To: Natasha Homsey, Environmental Assessment Officer – DP&E
From: Jessica Berry, Senior Environmental Consultant – pitt&sherry
Date: 30 August 2018
RE: Gunnedah Solar Farm – Fence Configuration 5

Figure 2 Fence Configuration 5 - Depth percentage change

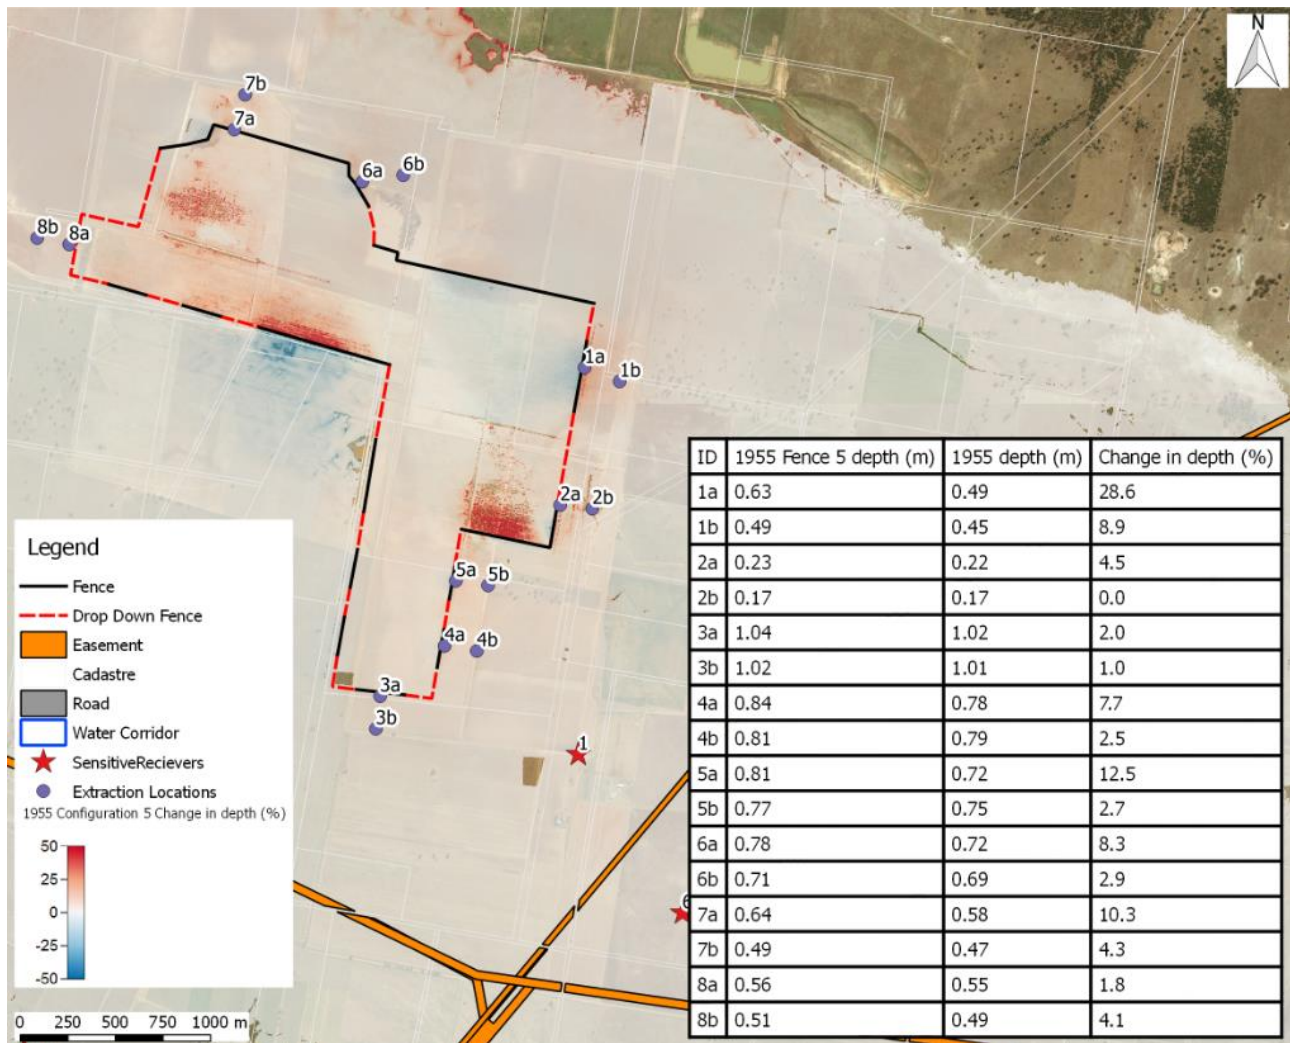
Fence Configuration 5 results in changes of depth outside the fence perimeter of less than 9% at a distance of 200m from the fence perimeter.

Figure 2 illustrates the depth percentage change between the fence configuration and the existing flood depths. Location 1a has the highest increase in depth of 28.6% increase, this level is adjacent the fence and at 200m from the fence the depth percentage change reduces to a 9% increase in peak flood depth.

For the majority of locations, the increase in flood depth is less than 5% at a distance of 200m from the fence perimeter.
